Addendum No. 1

Bid Opportunity: 7159-RW-22 – Smithson PS Office and HVAC Upgrades.

Closing Date: Monday, March 14th, 2022 2:00 PM

- LOCATIONS OF CONNECTIONS TO MECHANICAL EQUIPMENT IS APPROXIMATE AND SHOWN FOR REFERENCE ONLY. COORDINATE EXACT LOCATIONS AND TERMINATION REQUIREMENTS WITH MECHANICAL TRADE.

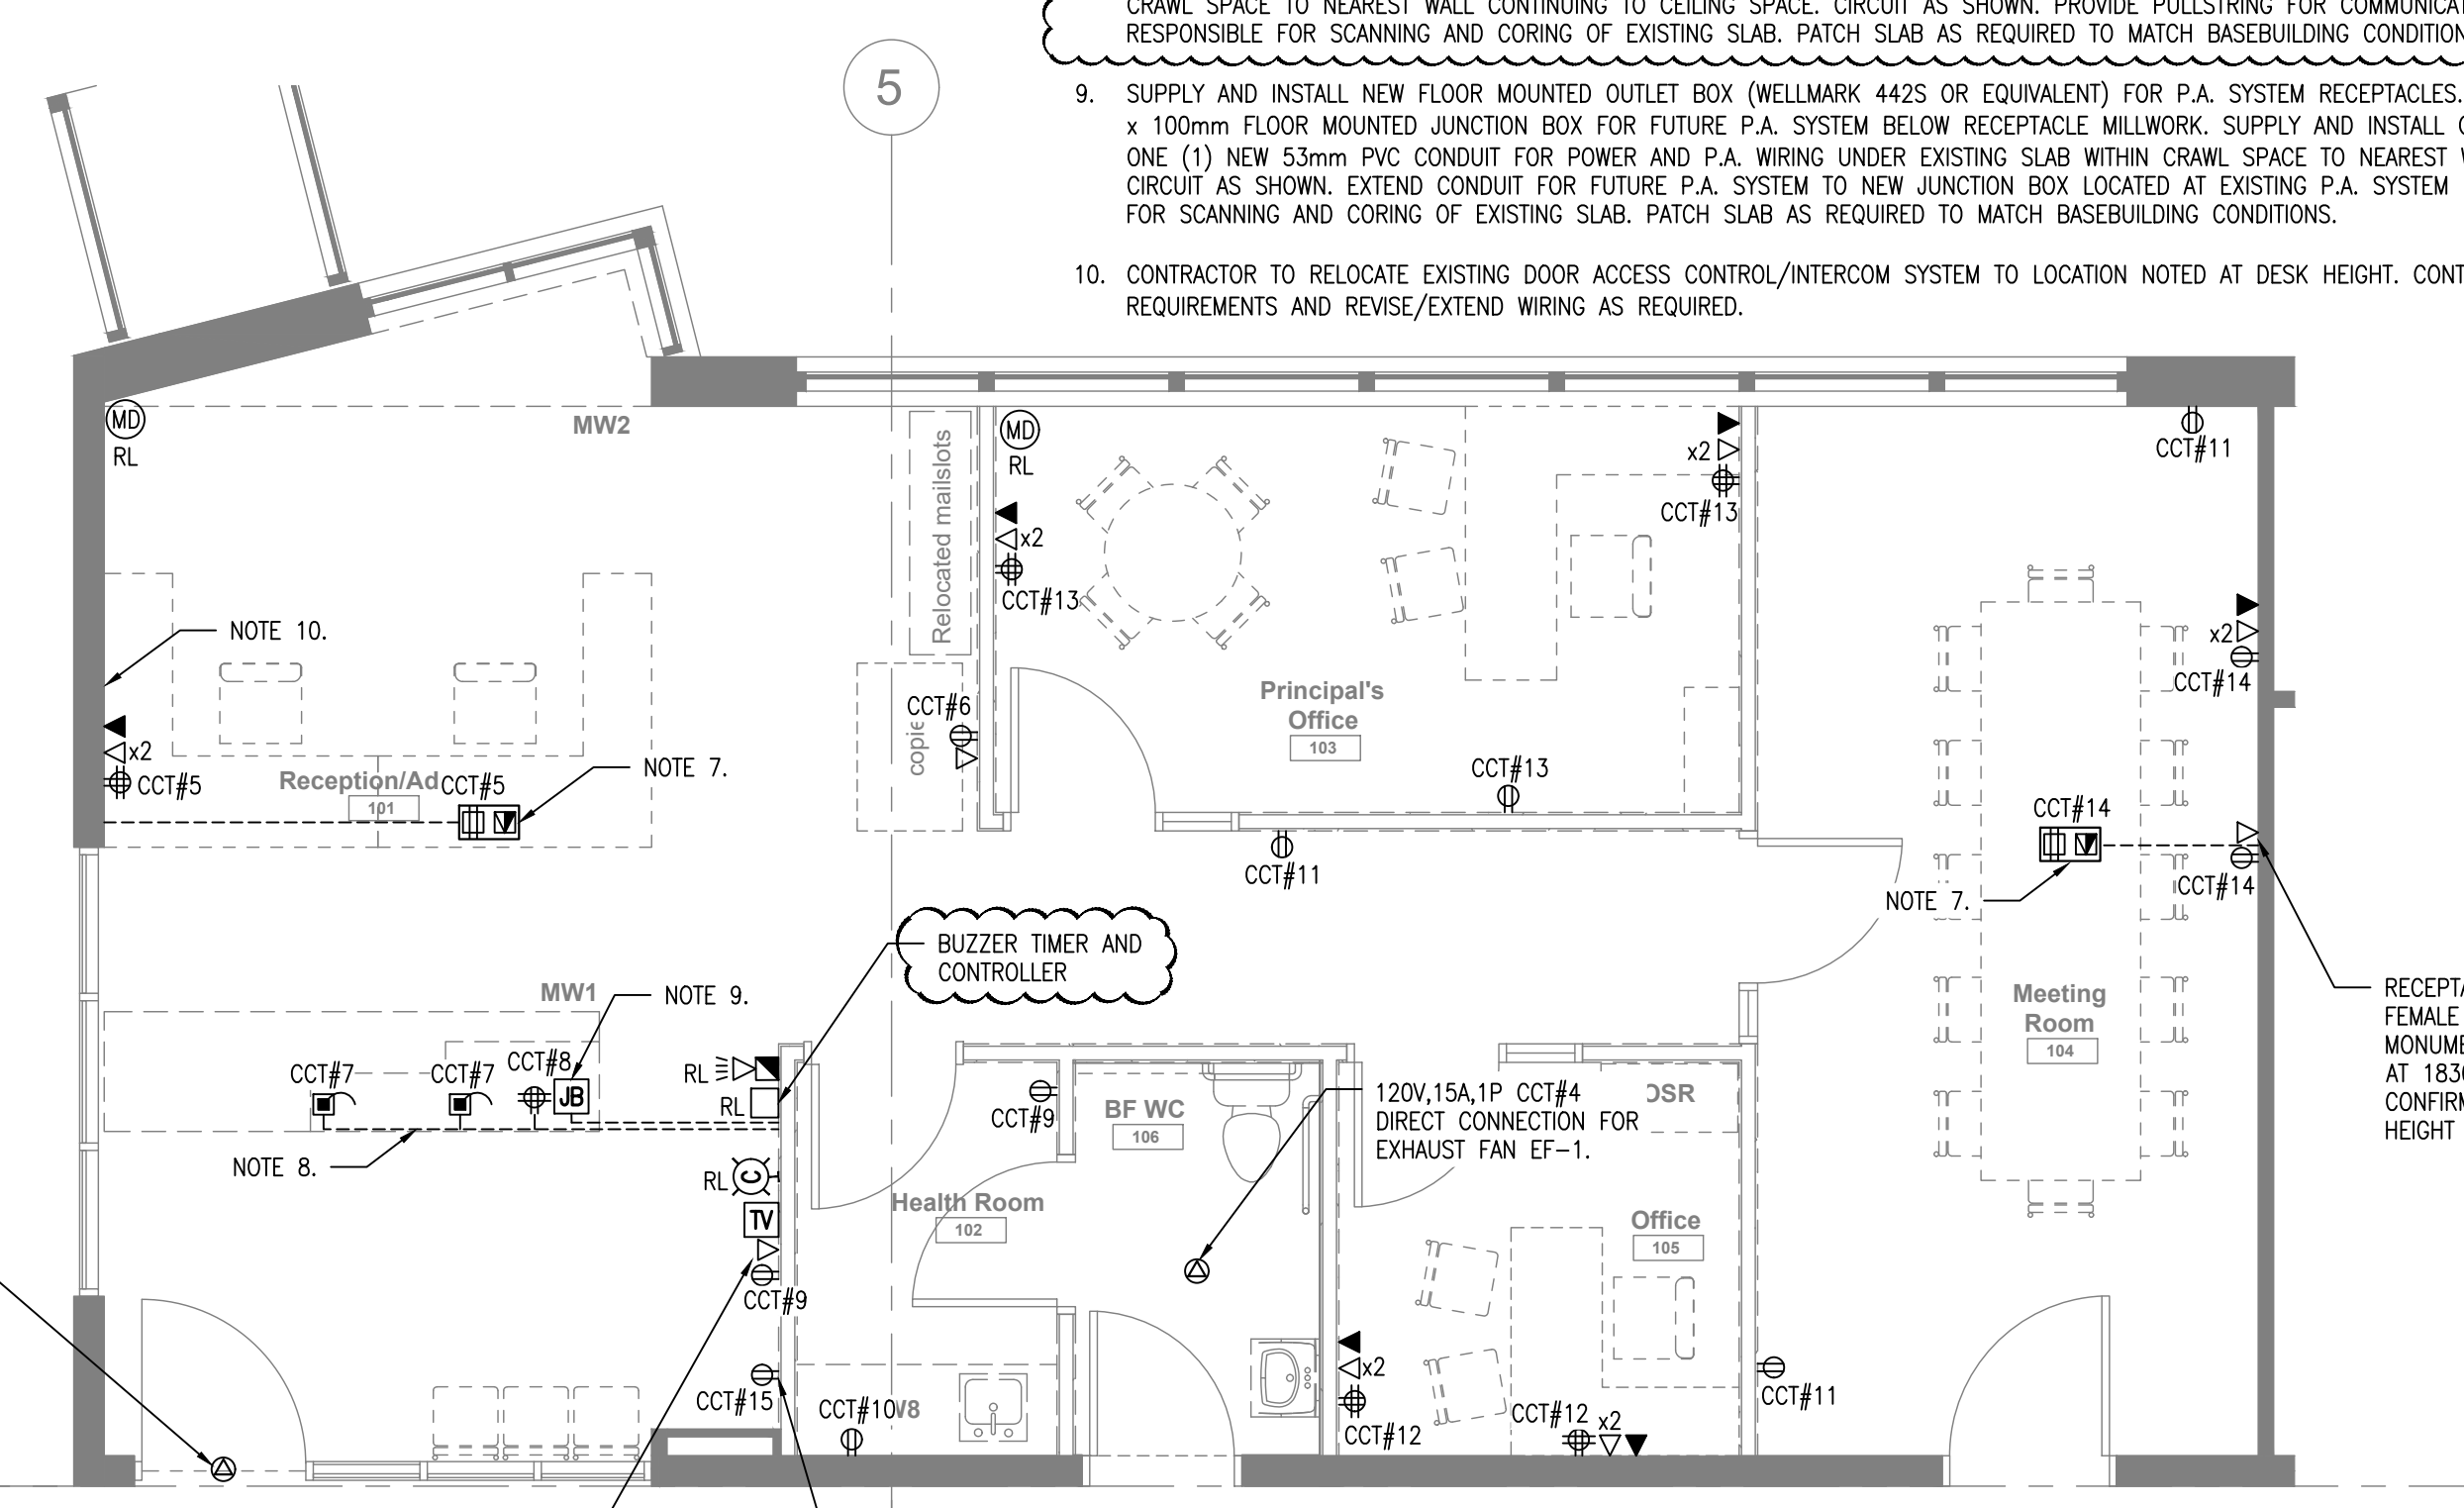
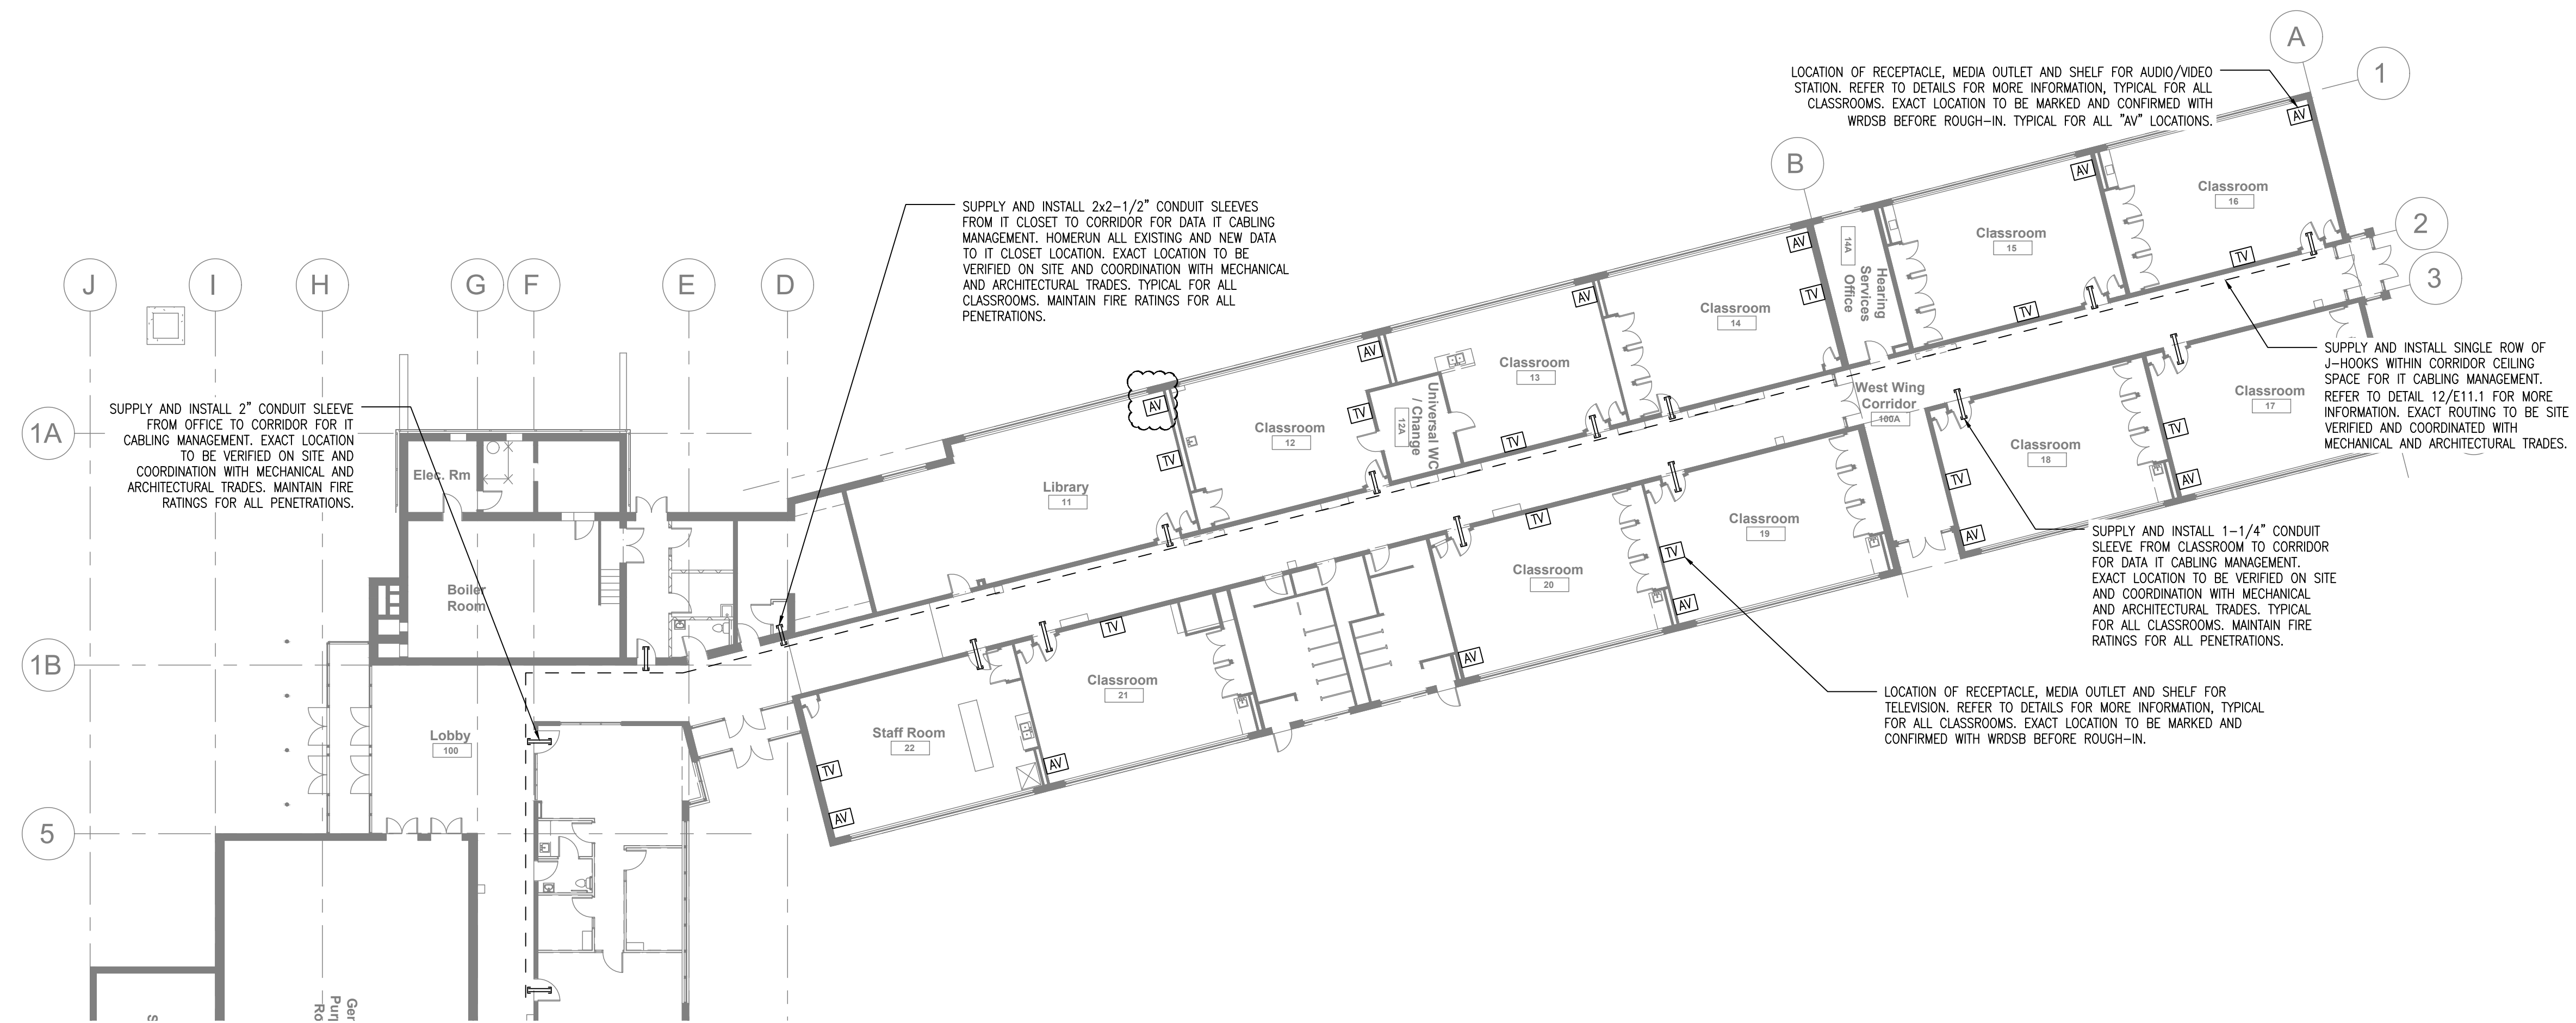
5. REFERENCE DRAWING E6 – PROPOSED POWER PLANS (ISSUED FOR ADD-E01)

1. Note 8 on drawing E6 has been revised to provide further information regarding the power and IT cabling to be provided at each furniture whip. Each furniture whip shall have 1xPower, 2x Data, and 1xPhone terminations. Confirm termination requirements will millwork and architectural trades.
2. Within the existing office space detail 3/E6, a device labelled as “TIMING SWITCH AND TIMER/CONTACTOR” which has been relocated, has been clarified to “BUZZER TIMER AND CONTROL”. This device shall be relocated as shown on layout drawings to facilitate the architectural changes within the office. Revise and/or extend wiring as required to facilitate the relocation.
